BUILDING CODE OF AUSTRALIA COMPLIANCE ASSESSMENT REPORT

C2 – IVANHOE VILLAGE & COMMUNITY CENTRE

IVANHOE ESTATE – LOT C2, EPPING ROAD, MACQUARIE PARK

REPORT NO. ► 11067.2

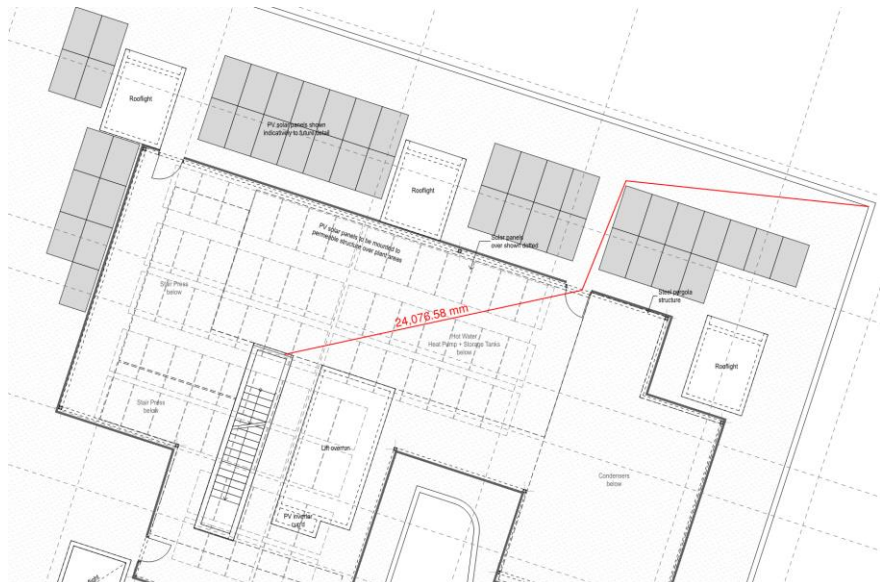
- Ground floor – Up to 22.5m to a point of choice in lieu of 20m from the bin holding area.
